ADDENDUM 1

DATE: 01/30/18
PROJECT: UCT Expansion Interior Buildout
RFP NO: RFP 744-R1805 – UCT Expansion Interior Buildout
OWNER: The University of Texas Health Science Center at Houston
TO: Prospective Proposers

D2 LG CONF ROOM ELEVATION EAST - ADD ALTERNATE 1 SCALE: 3/8" = 1'-0"
D3 LG CONF ROOM ELEVATION EAST - ADD ALTERNATE 2 SCALE: 3/8" = 1'-0"

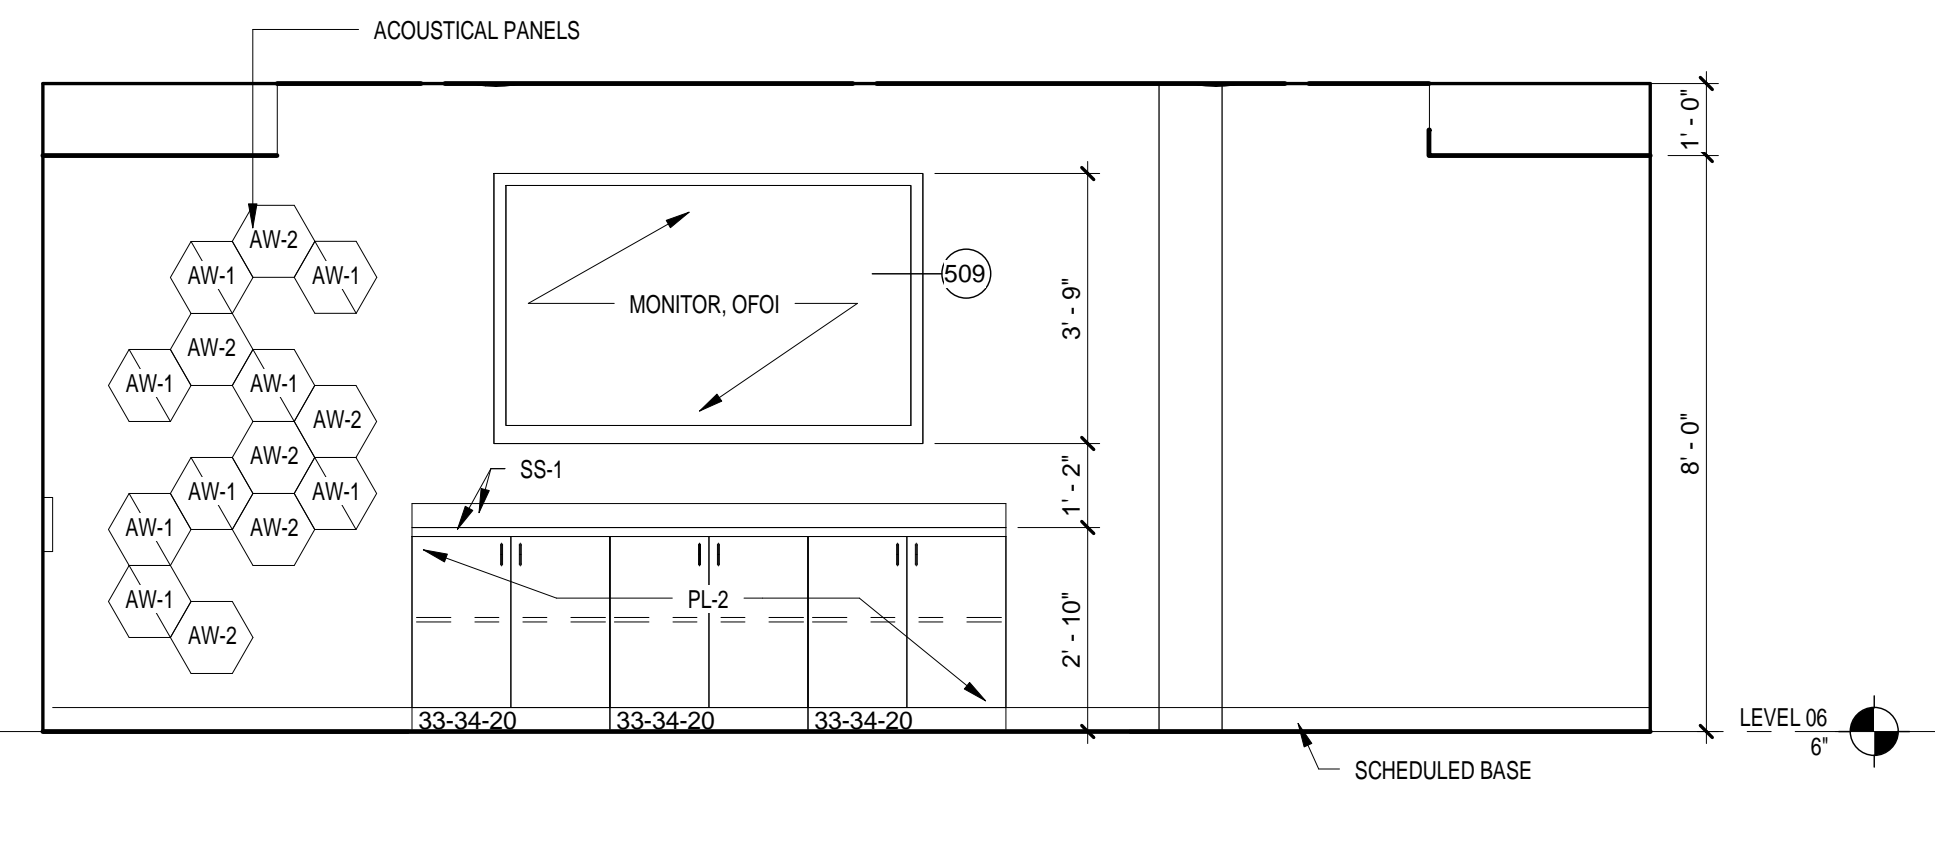
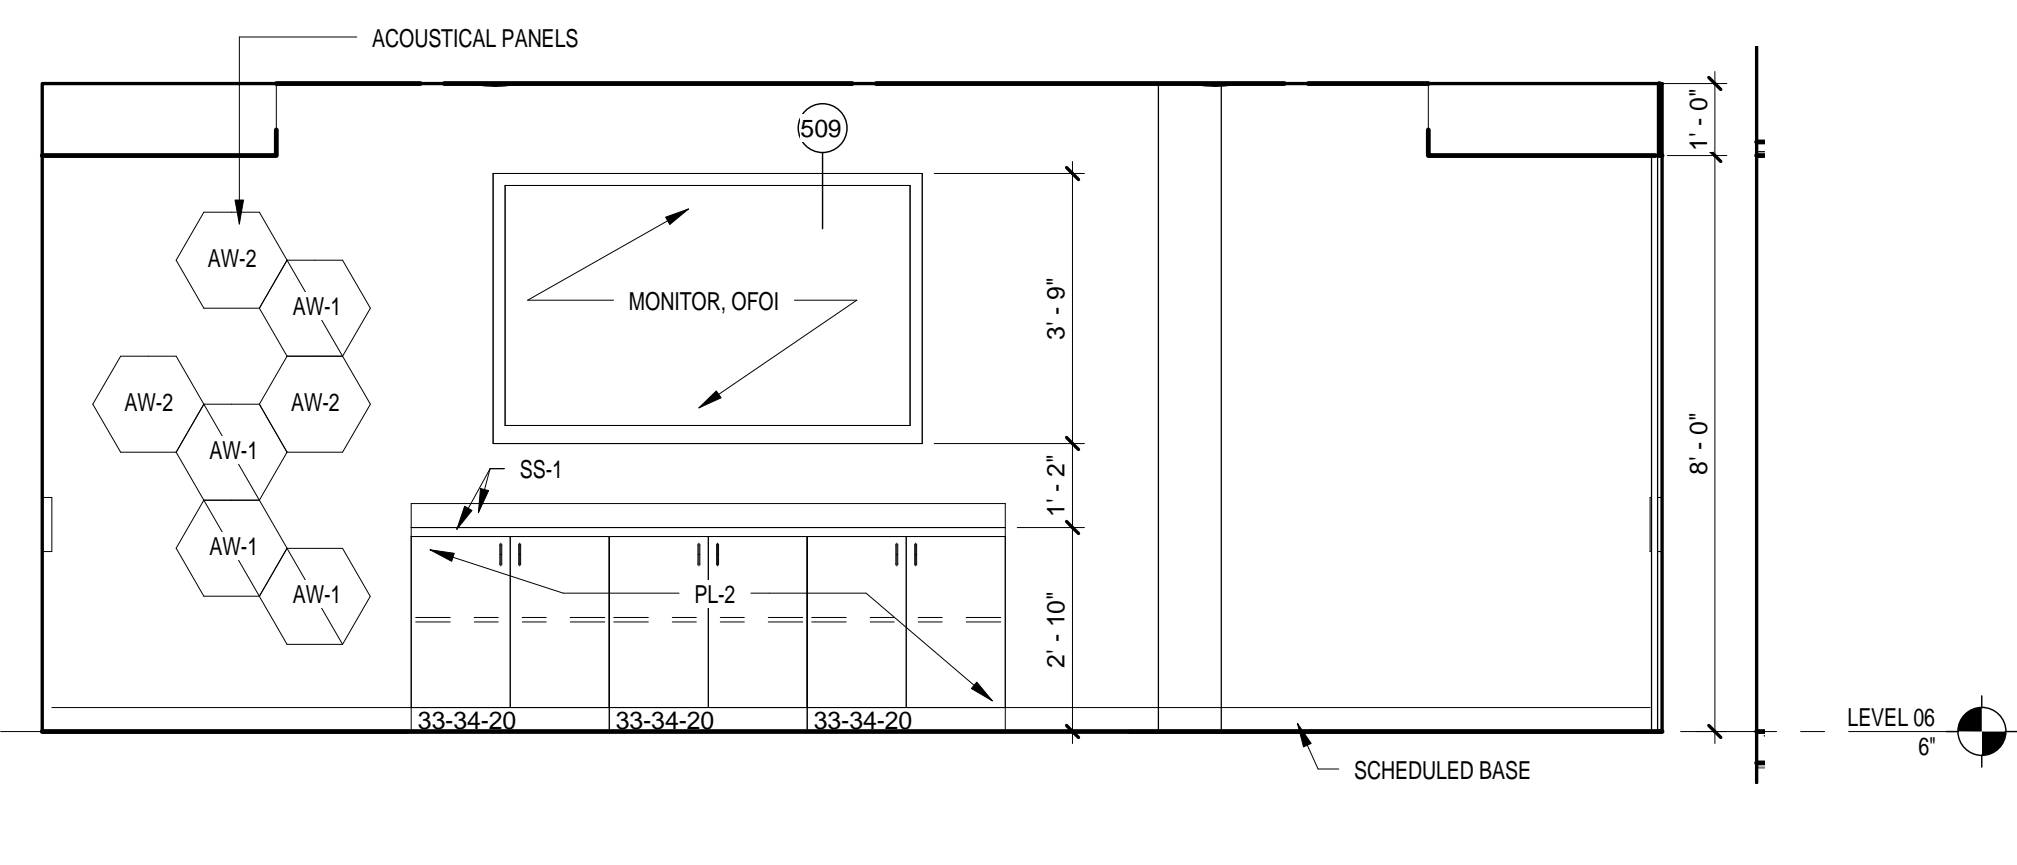
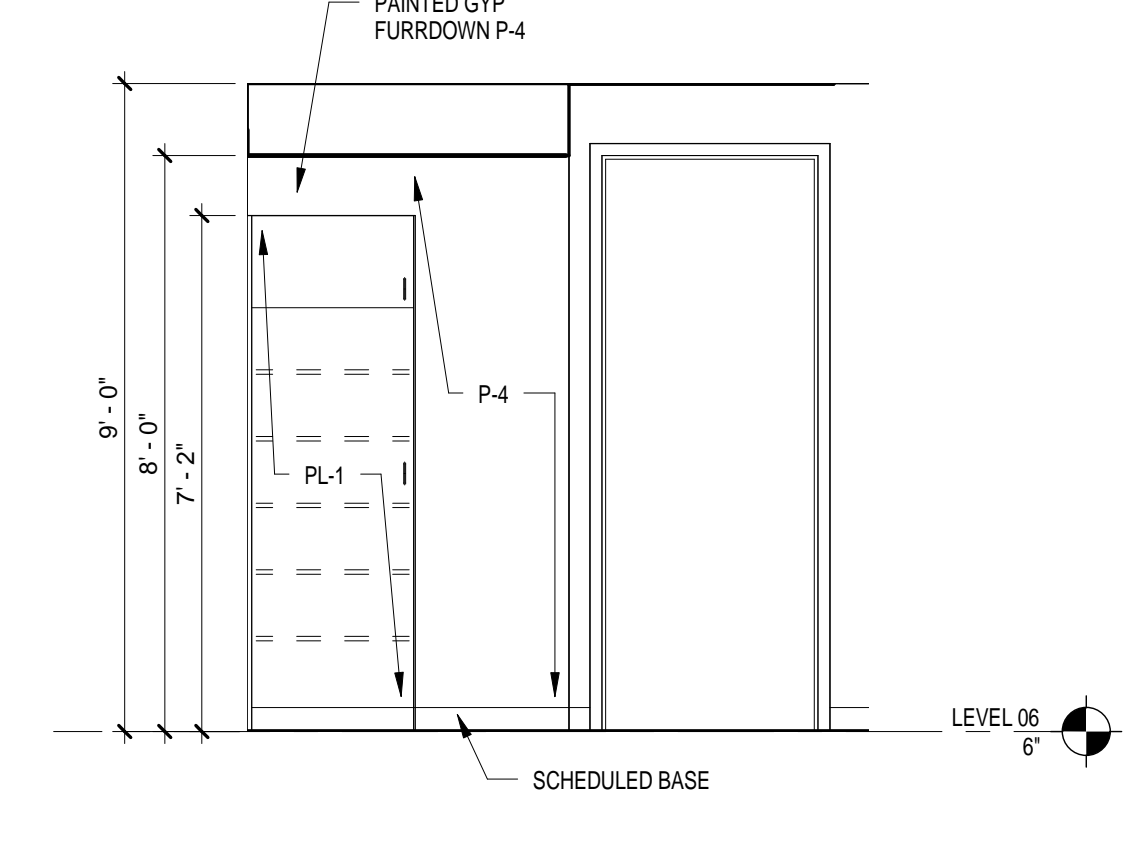
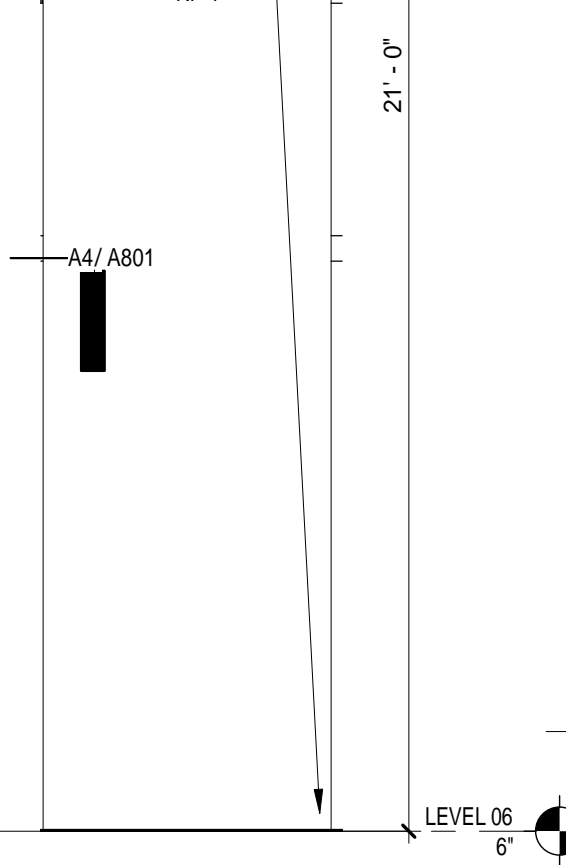
38. Sheet A702 – Details C/D2 & 3 indicate hexagon shaped acoustical wall panels. Please provide product specification for these panels.

a. These appear to be Xorel ArtForm Hex Panels. If they are, please clarify if the panels with a diagonal line are to be the 3D panels, and provide a core material selection.

50. Per details C1 and C3 on drawing A701, and details D2, D3, C2, and C3 on A702 the monitors are called out to be Owner Furnished, Owner Installed. The note #509 stated that these monitors are to be Contractor Furnished, Contractor Installed. Please clarify who furnishes and installs these monitors.

Yes, diagonal lines indicate 3D panels. Spec Attached. Core material to be Quiet-Core (Not recommended as a tackable surface)

PROJECT NO: 1015236.03
AR106
Copyright © 2017 WHR Architects, Inc.

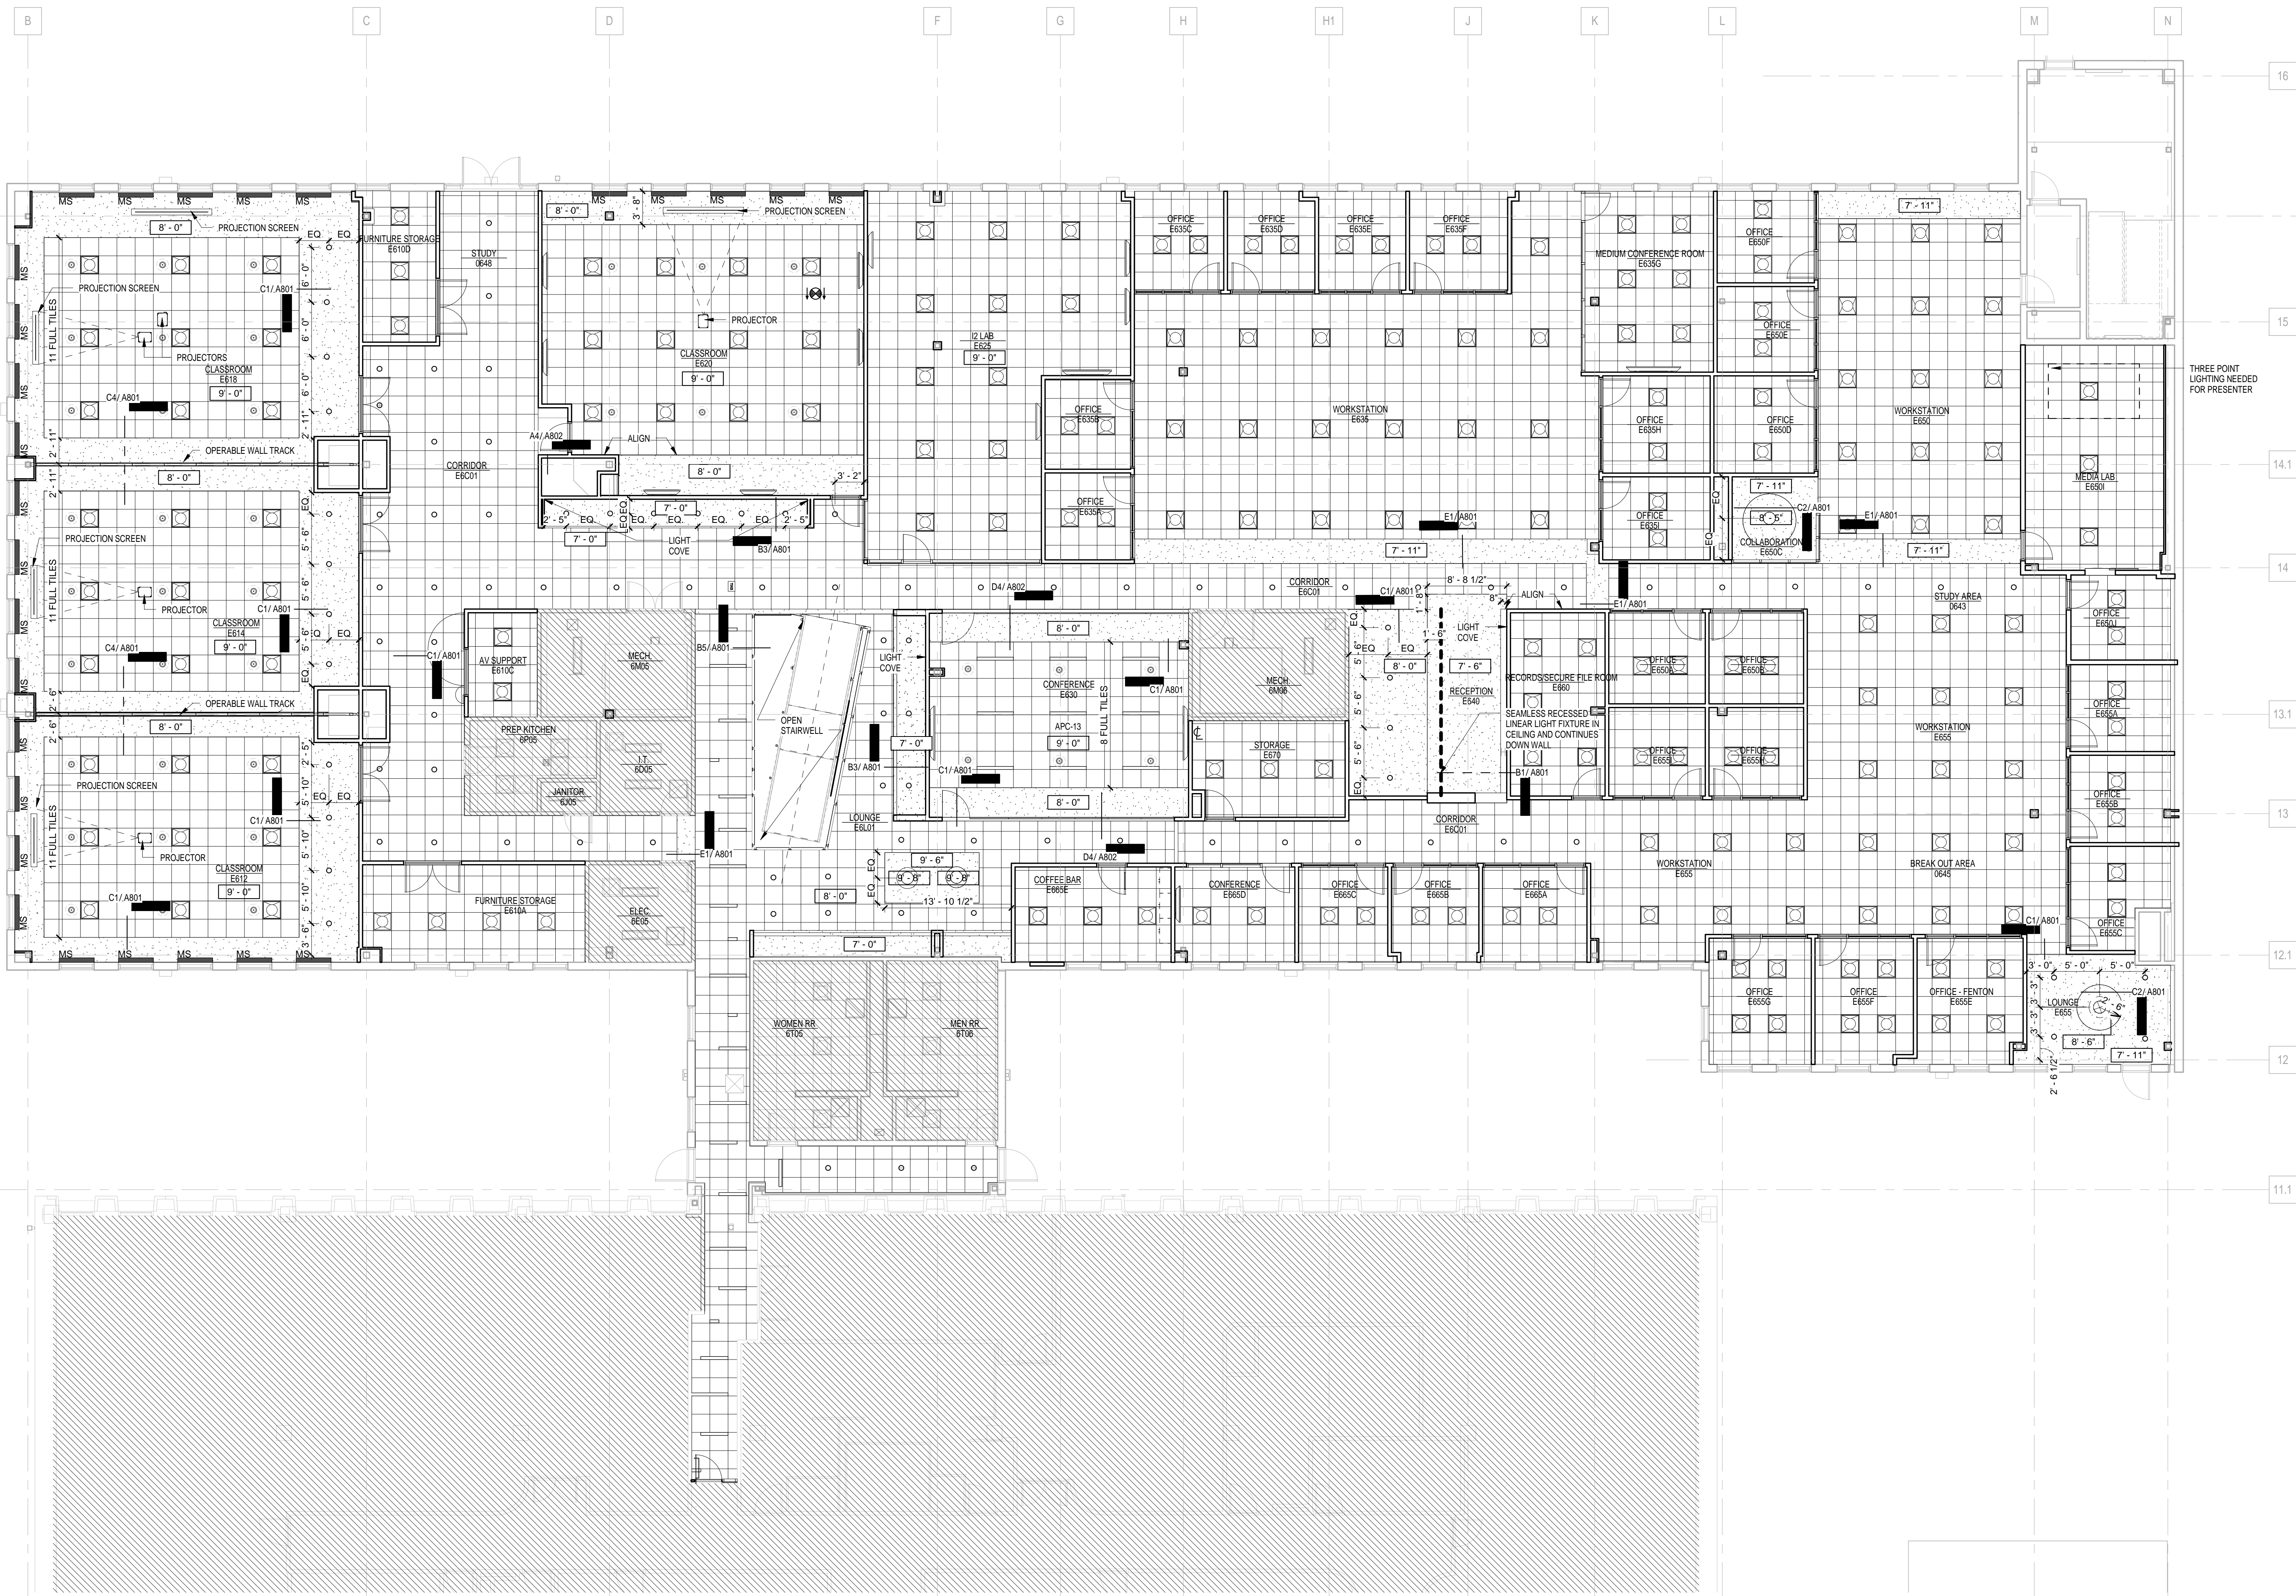
28. Sheet AR106 – Reception E640 shows a Light Cove at the plan east wall of the Reception. There is no light fixture shown in the location on the Lighting Plan (EL106). Please clarify.

Drawing provided in Addendum 1 documents.
